BYRON - UNITS 1 & 2

### **PROPOSED CHANGES TO APPENDIX A, TECHNICAL SPECIFICATIONS, OF FACILITY OPERATING LICENSES NPF-72 AND NPF-77**

### **BRAIDWOOD NUCLEAR POWER STATION, UNITS 1 AND 2**

## **EVALUATION OF SIGNIFICANT HAZARDS CONSIDERATIONS FOR PROPOSED CHANGES TO APPENDIX A, TECHNICAL SPECIFICATIONS, OF FACILITY OPERATING LICENSES NPF-37, NPF-66, NPF-72, AND NPF-77**

TABLE 3.3-1

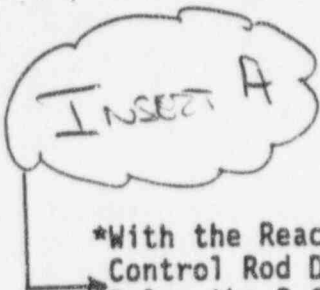
## INSERT A

- \*\* With Reactor Trip System Breakers in the open position. In this condition, source range function does not provide reactor trip, but does provide input to the Boron Dilution Protection System (Technical Specification 3.1.2.7) and indication.

REPLACE WITH  
INSERT B

~~ACTION 5 - With the number of OPERABLE channels one less than the Minimum Channels OPERABLE requirement restore the inoperable channel to OPERABLE status within 48 hours or within the next hour open the reactor trip breakers, suspend all operations involving positive reactivity changes, and verify valves CV-111B, CV-8428, CV-8439, CV-8441, and CV-8435 are closed and secured in position. With no channels OPERABLE verify compliance with the SHUTDOWN MARGIN requirements of Specification 3.1.1.1 or 3.1.1.2, as applicable, and take the actions stated above within 1 hour and verify compliance at least once per 12 hours thereafter.~~

## INSERT B

- Action 5a- With the number of OPERABLE channels one less than the Minimum Channels OPERABLE requirement, restore the inoperable channel to OPERABLE status within 48 hours or within the next hour open the reactor trip breakers. With no channels OPERABLE, immediately open the reactor trip breakers.
- Action 5b- With no channels OPERABLE, immediately suspend operations involving positive reactivity additions and within 1 hour verify valves CV-111B, CV-8428, CV-8439, CV-8441, and CV-8435 are closed. Also, within 1 hour and at least once per 12 hours thereafter, verify compliance with the SHUTDOWN MARGIN requirements of Specification 3.1.1.1 or 3.1.1.2, as applicable.
